# **PROPOSED CHANGES TO FITZGERALD PARK PRECINCT PLAN RELATED TO 10<sup>TH</sup>/CEDAR LRT STATION**

**Prepared by  
The Saint Paul on the Mississippi Design Center**

**For the  
City of Saint Paul Planning Commission  
CapitolRiver Council**

**April 2010**

**Figure 1. The station area at 10<sup>th</sup>/Cedar is designed as an “urban room,” a high-quality public space where pedestrians, cyclists, transit and cars interact.**

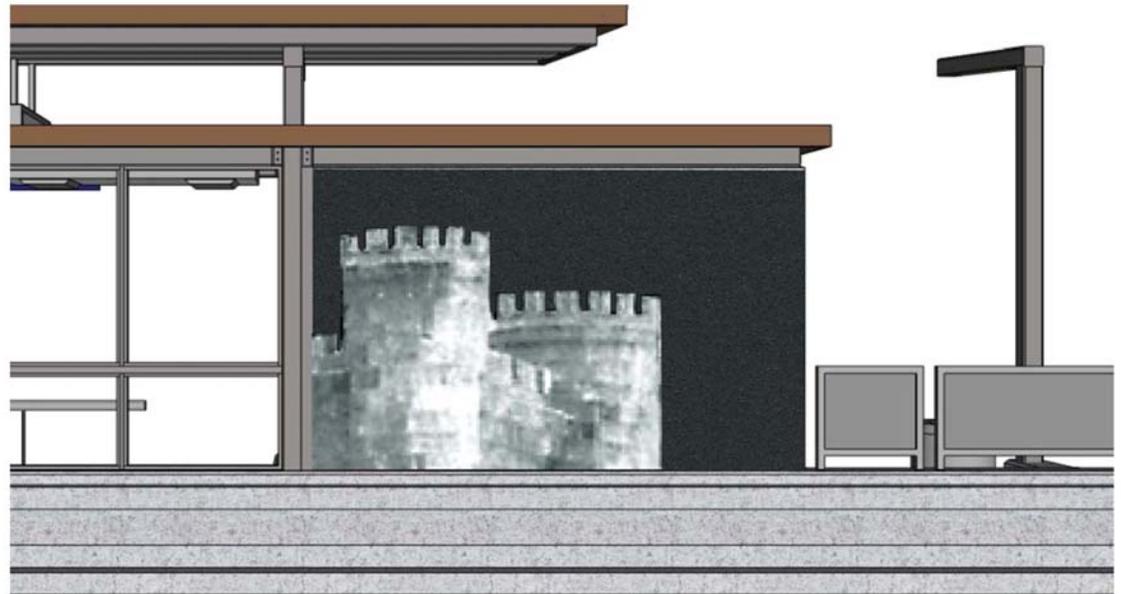
14. Public realm improvements should be designed to create an “urban room” at the 10<sup>th</sup>/Cedar LRT station. This urban room should be a high-quality public space capable of integrating the needs of a wide range of users and accommodating pedestrians, cyclists, transit and cars. This will also improve the visibility of Cedar Street as a gateway to both the precinct and downtown.

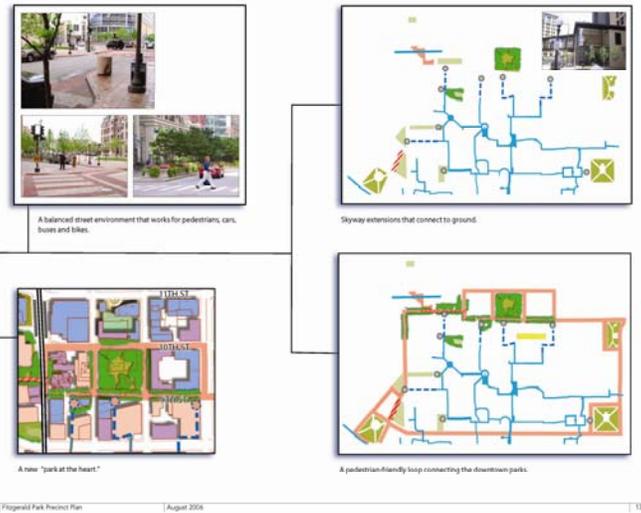
3. Ninth, 10<sup>th</sup>, Cedar between MPR and Exchange, Exchange and St. Peter streets should be redesigned as “park streets.”
13. A Mobility Enhancement Area should be created adjacent to the 10<sup>th</sup>/Cedar LRT station. As with the other Mobility Enhancement Areas along the Central Corridor line, the intent is to prioritize the movement of pedestrians and cyclists to and from LRT, increase a sense of personal safety, and facilitate transfers between different transport modes. The Mobility Enhancement Area should be designed with an enhanced streetscape, wayfinding, arts and cultural expression, and a landscaping strategy that integrates pedestrians, cyclists, buses and LRT, and generally improves the experience of using transit.
